Bush Terminal Piers Park

NYC Public Design Commission
Final Review
August 14, 2023

Bush Terminal Piers Park | Phase 2 - Picnic Area Enlargement Plan

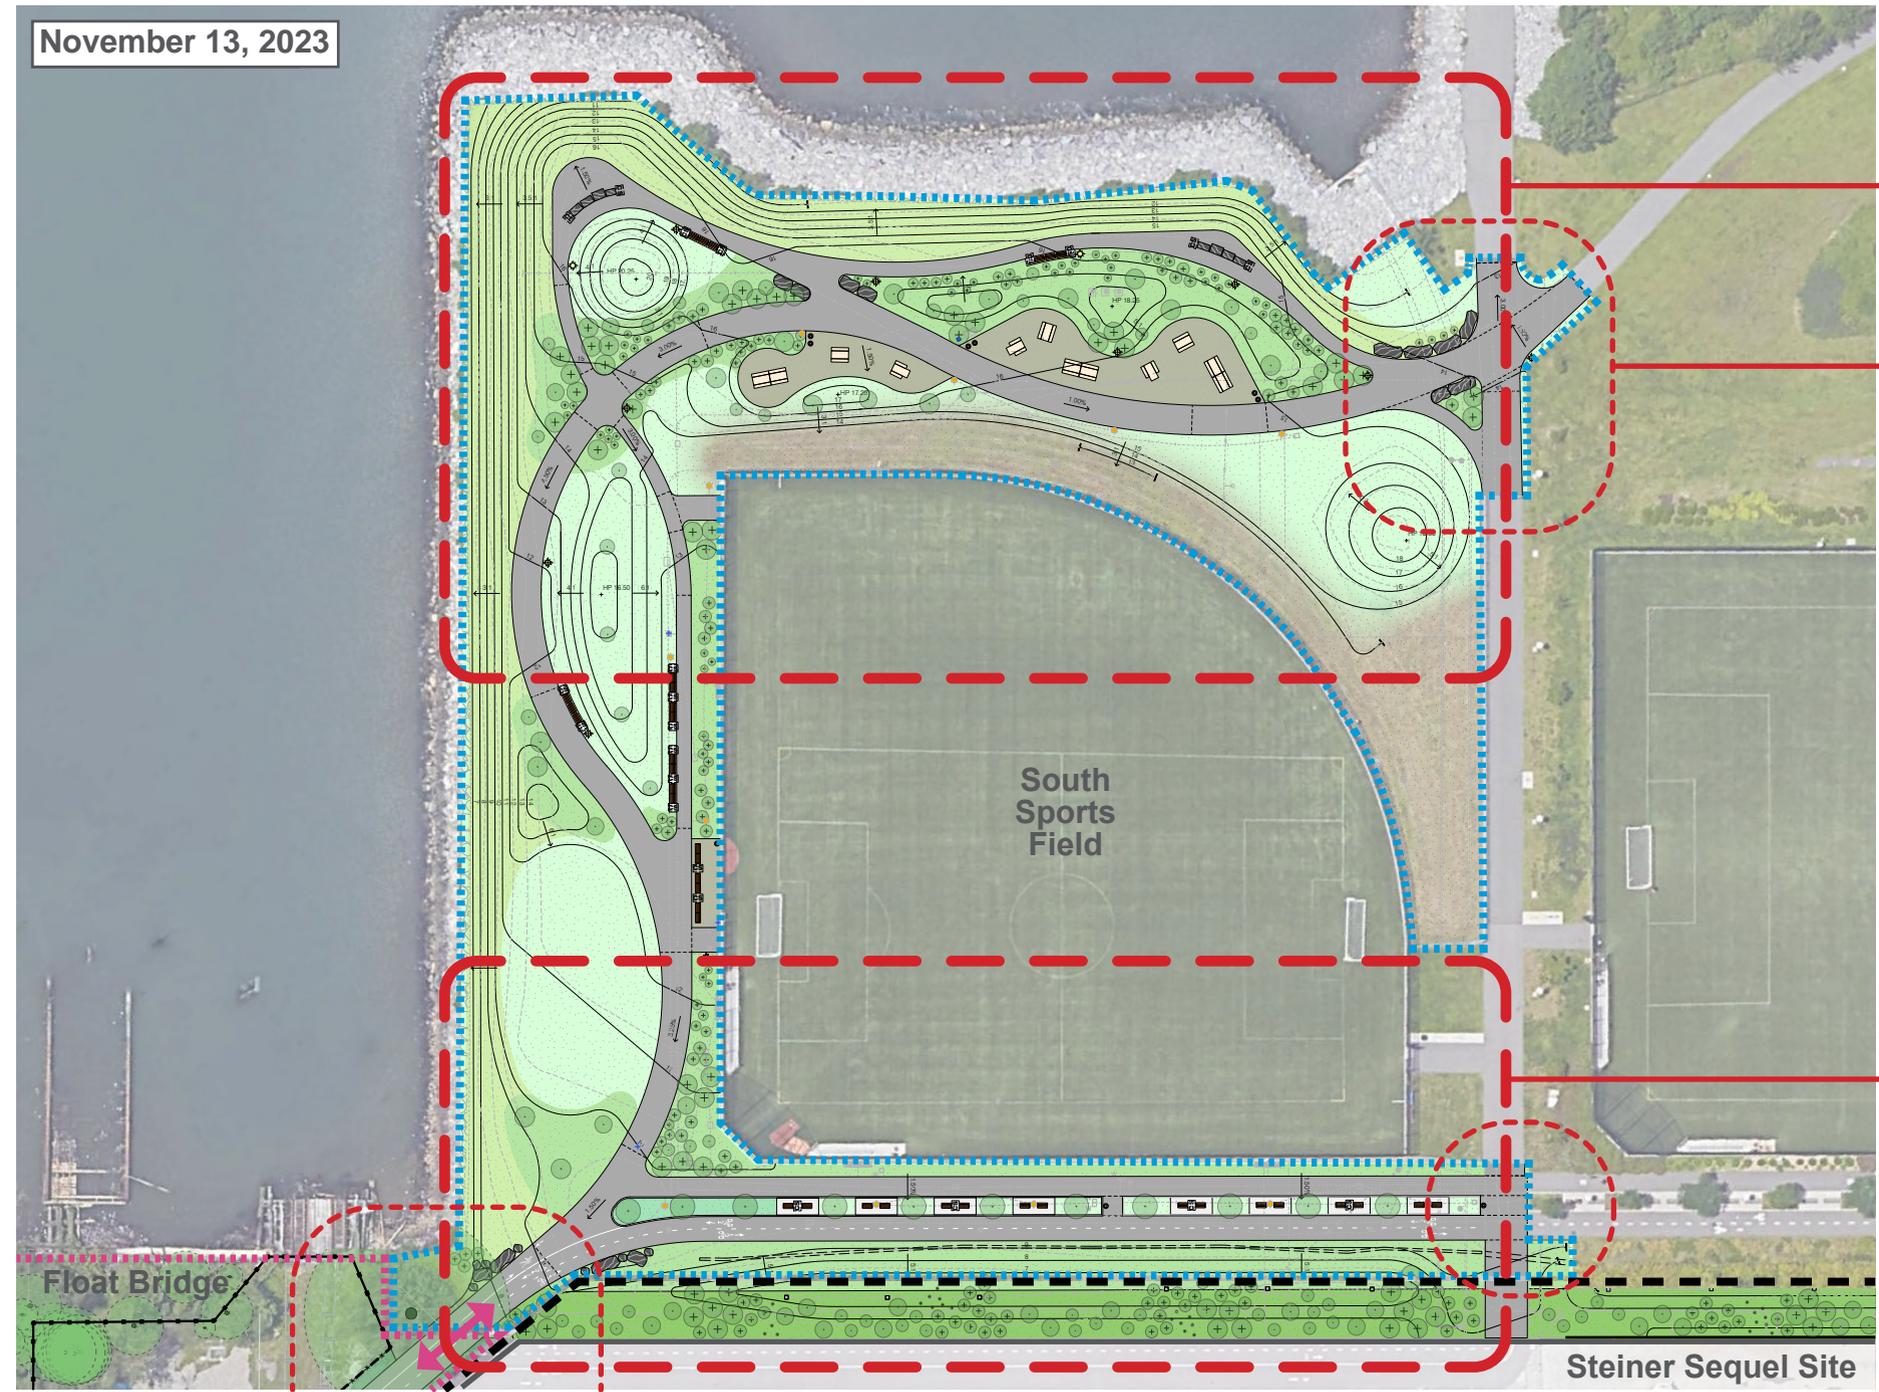
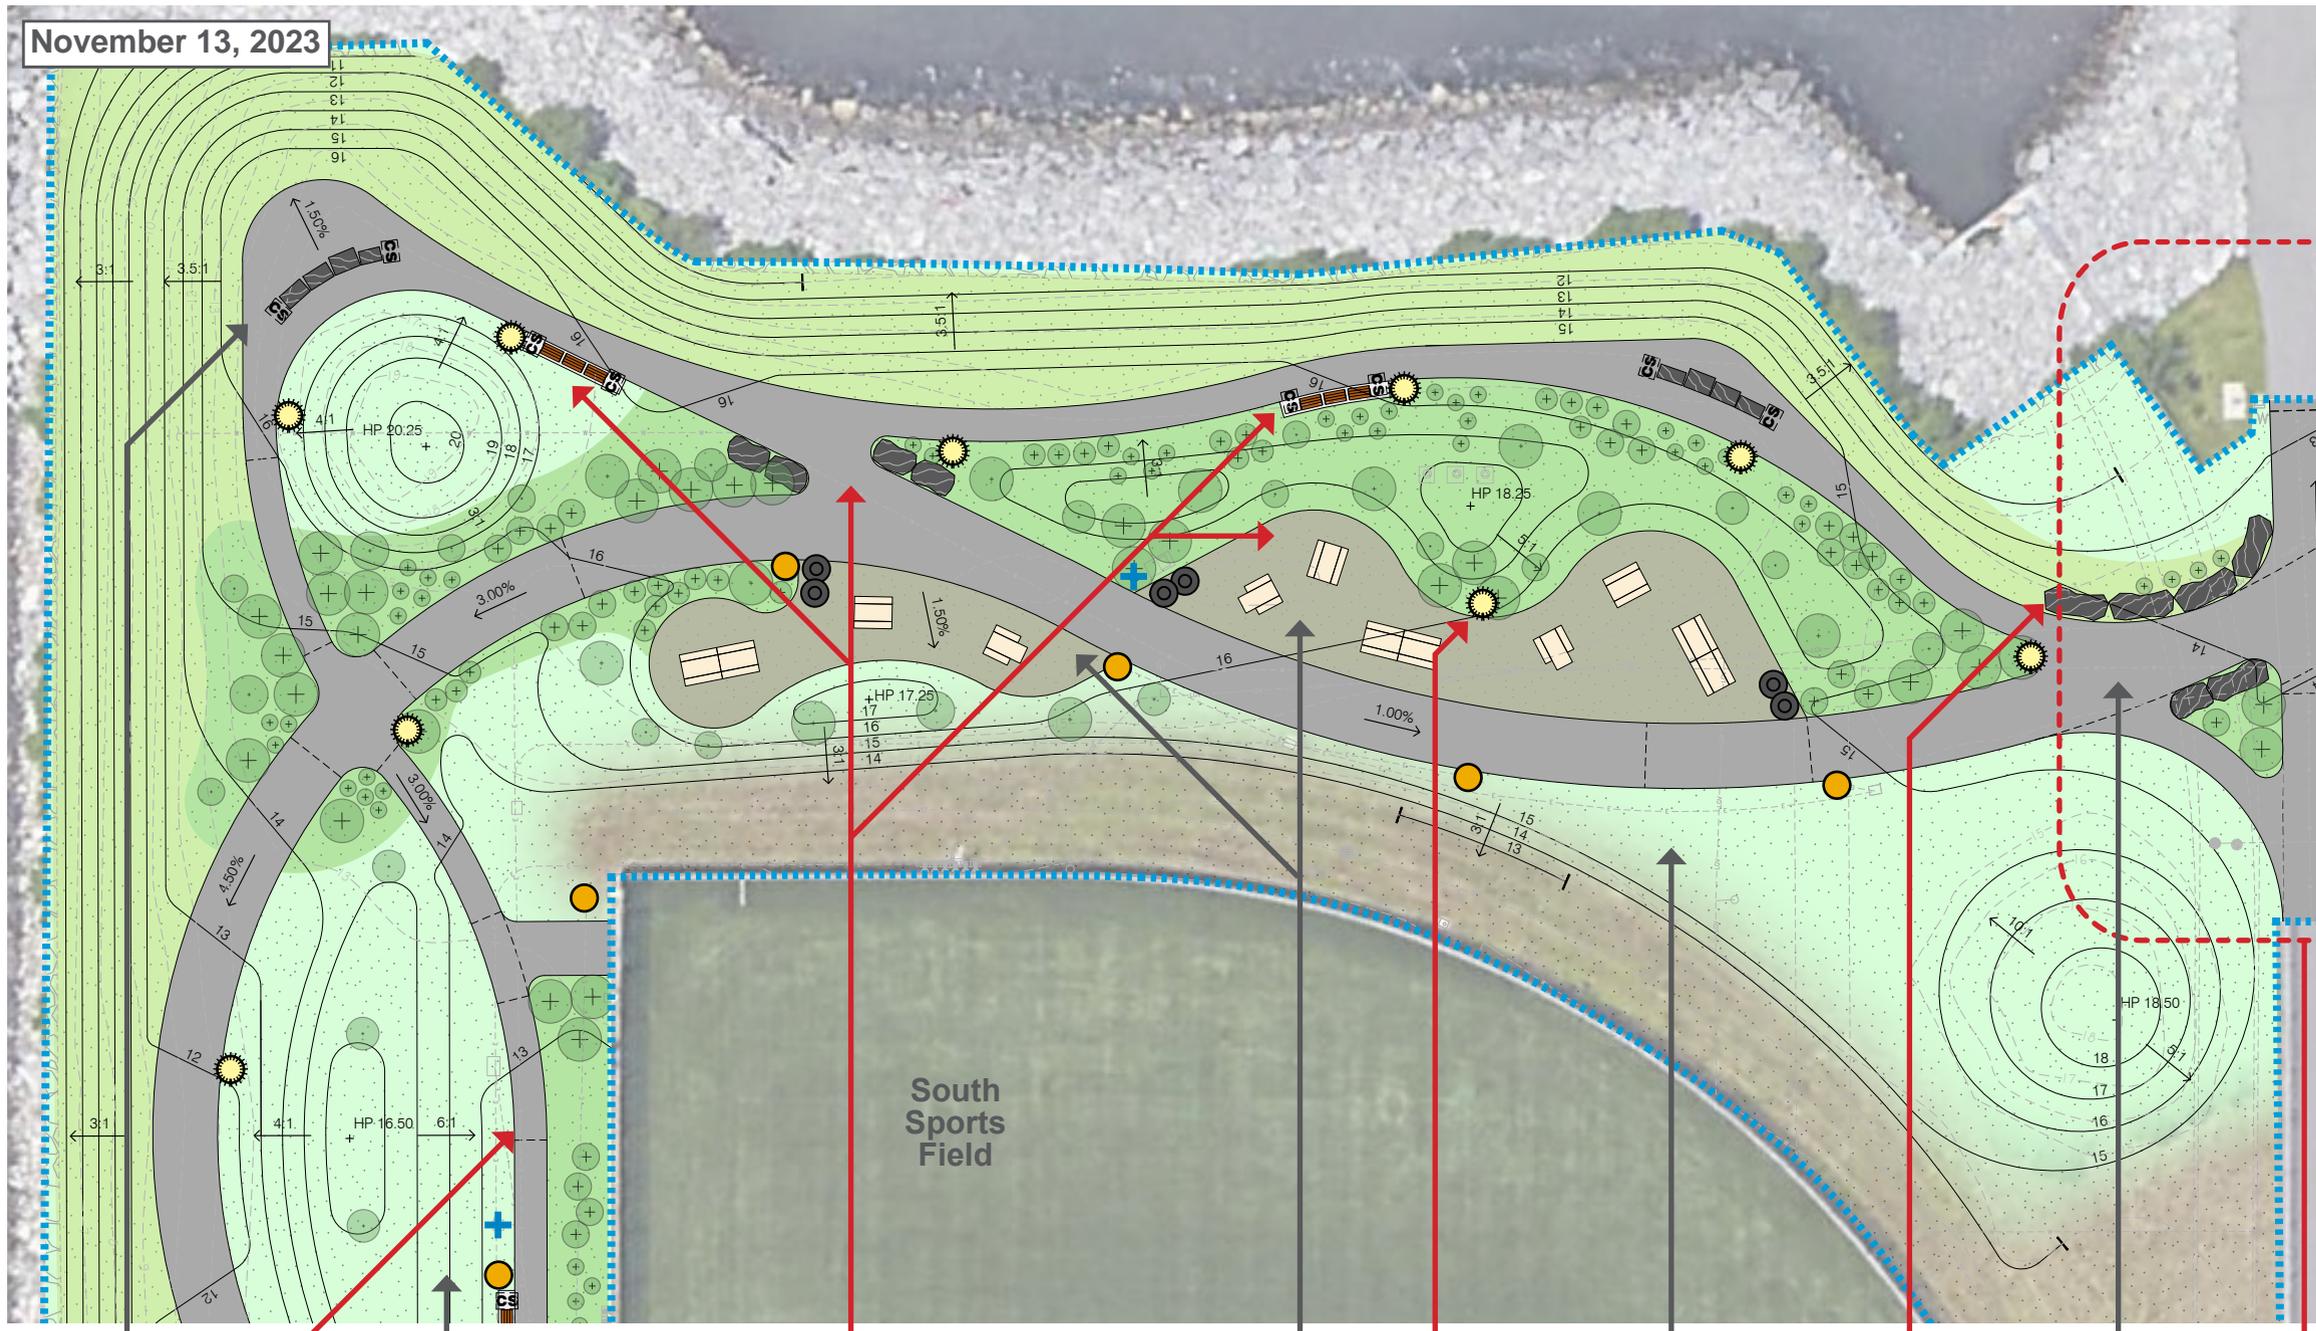
Picnic Area Revisions

Promenade Revisions

Secondary Path Width Reduced, Typ. Paving + Bench Layout Refined Light Poles Added Per DOT, Typ. Stone Slabs Added, Typ. Limit of Work Revised

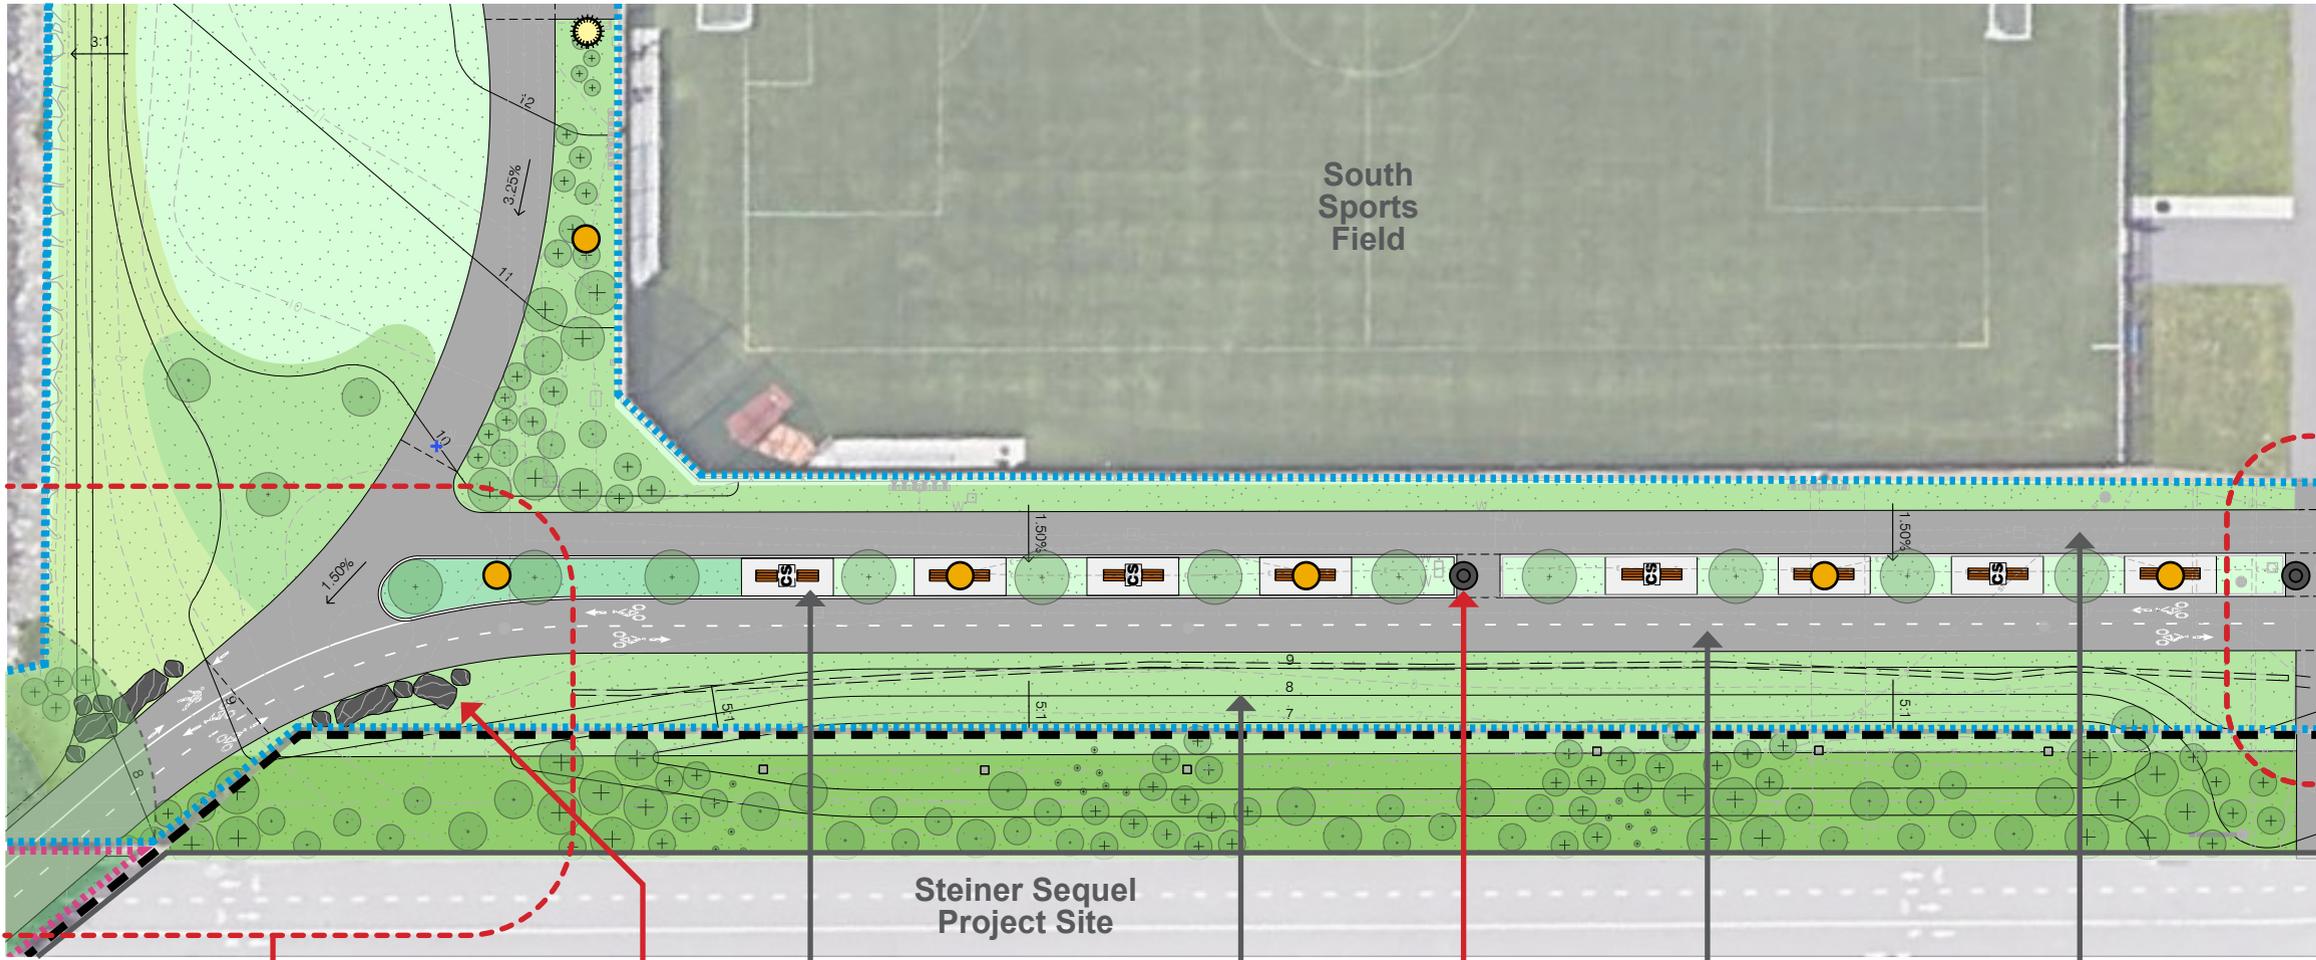
Relocated South Park Entrance
Limit of Work Revised

Stone Slabs
Added, Typ.

Waste Receptacles Relocated, Typ.

Limit of Work Revised

Improved, Safer Transition between
Phase 2 Area and Float Bridge Site
